# 1997 - 1998, 2000 Corvette: Service Bulletin: Electronic Steering Column Lock May Refuse to Operate - DIC Service Message Displayed

**Number:** 01-02-35-008

**Subject:** Electronic Steering Column Lock May Refuse to Operate - DIC Service Message Displayed (Update Column Lock Wiring, Install Revised Relay and/or Replace Electronic Column Lock)

**Model Year:** 1997-1998, 2000 Chevrolet Corvette Built Between the Following VIN Breakpoints:

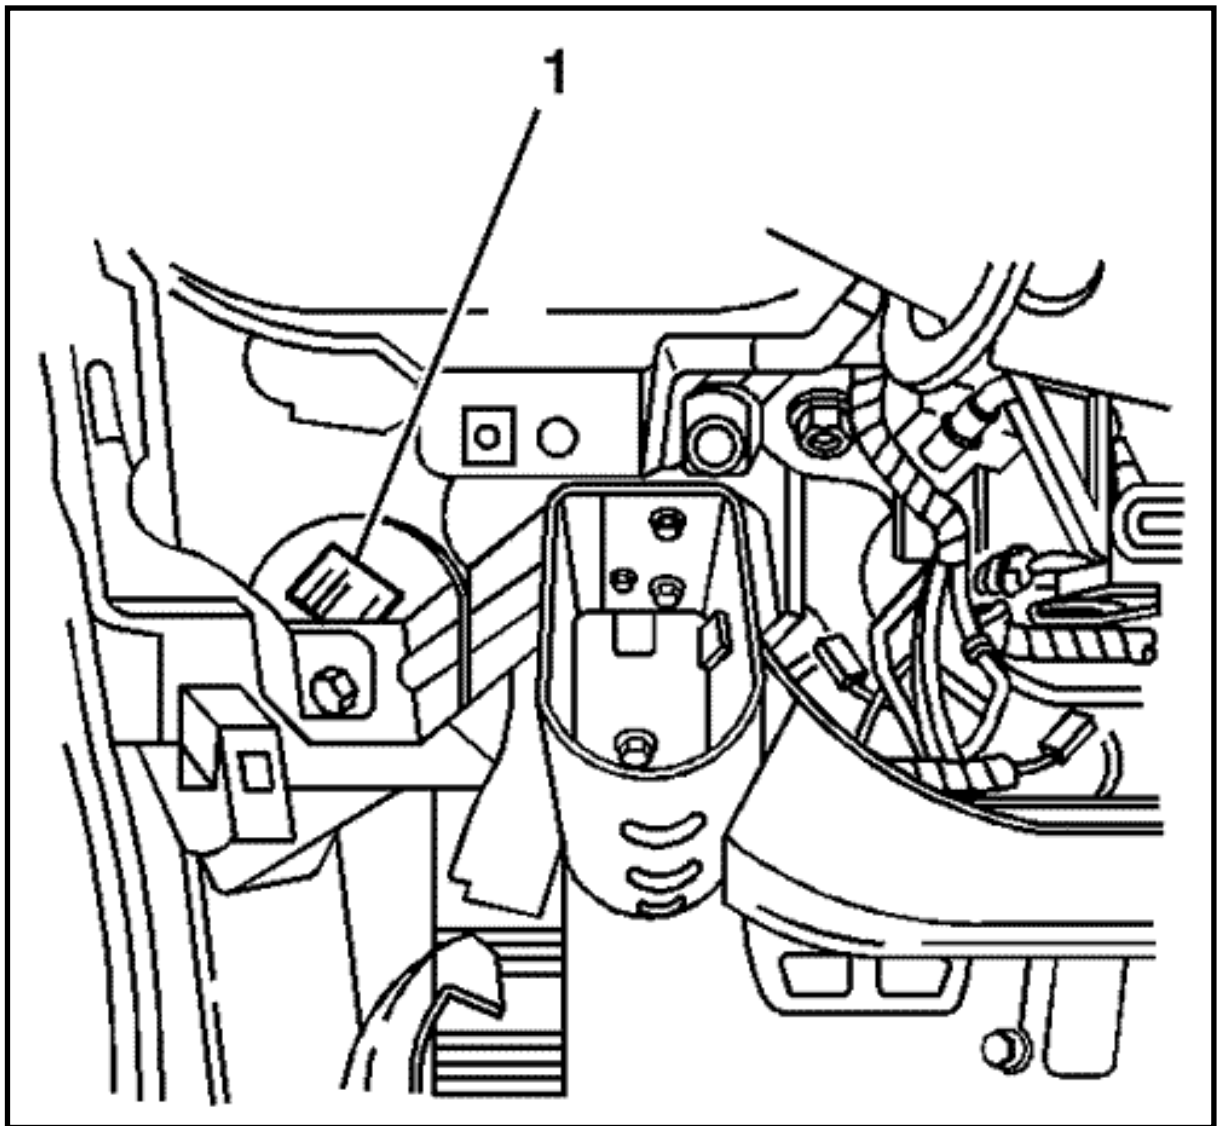
13. Install the included Cam Orientation Plate and secure with a new locking ring, using J 42137 and J 38364 as shown.
14. Install the SIR coil and secure with snap ring.
15. Disconnect the connector from the ECL (located on the right lower side of the steering column) to the I/P main harness.

**FIGURE 1997 and 1998 (early) Manual (U.S. & Canada and All Export (Manual & Auto)(c)**

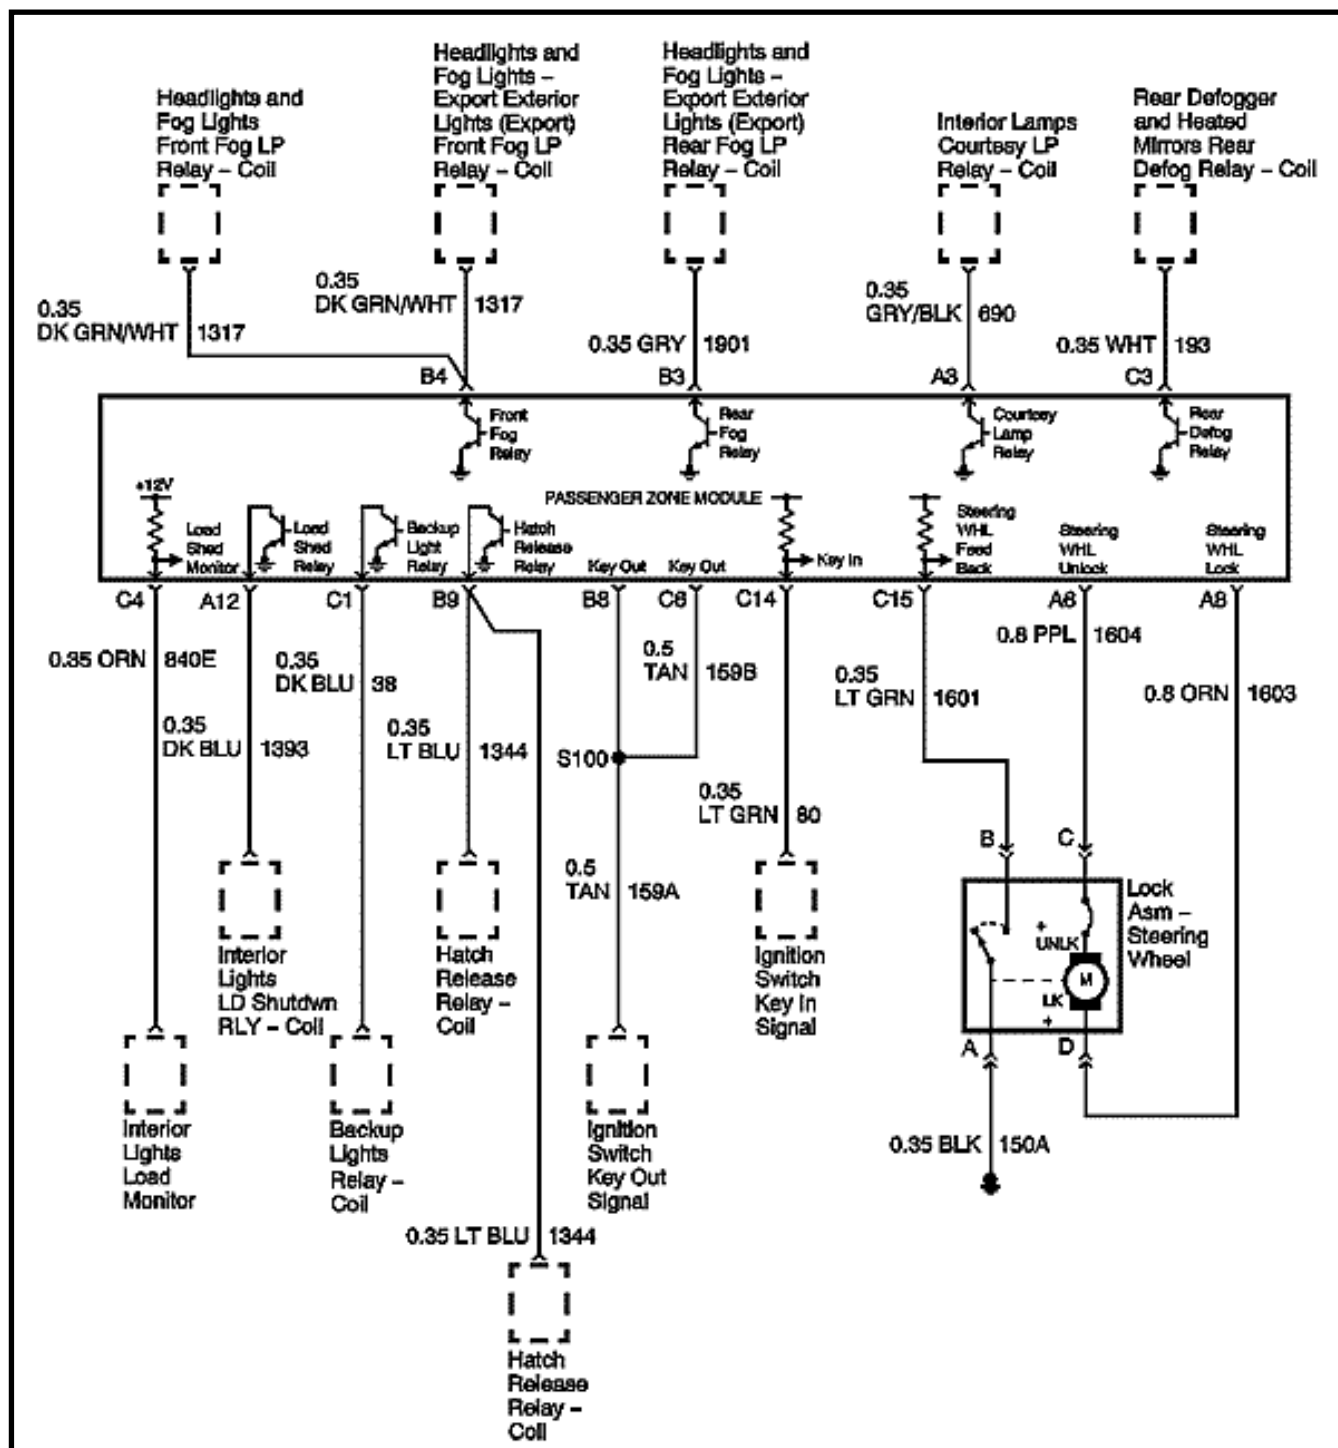
- **In order to complete the wiring upgrades listed in the section, you will need to order P/N 88952428, Wire Kit, Strg Wheel Theft Dtrnt.**
- **You may use the included schematics to aid in verifying the installation of the new relay and jumper wire.**

FIGURE 1997 and 1998 (early) Automatic (U.S. & Canada)(c)

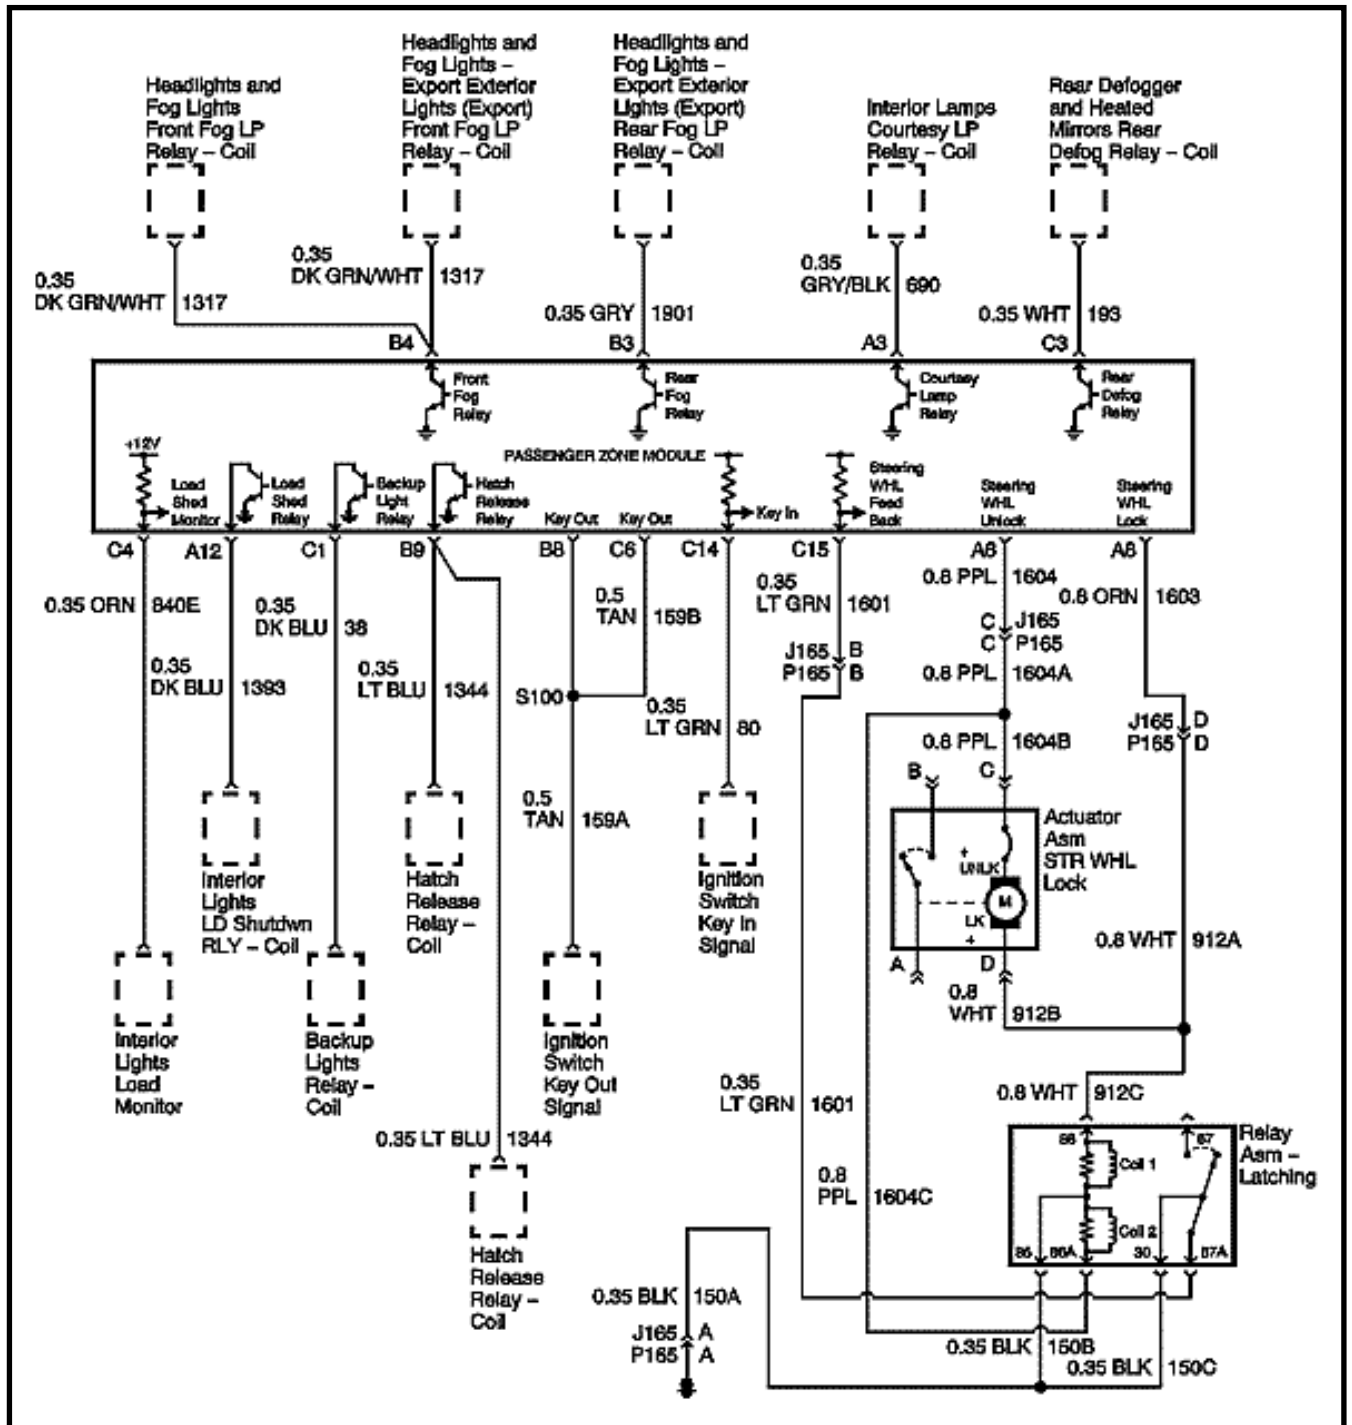
- **When removing the driver's side knee bolster trim panel as described below, care must be taken not to damage the console trim plate as the knee bolster trim panel tucks in behind the console trim plate.**
- **Revised schematics are included to aid and/or verify the proper installation of the service kit.**
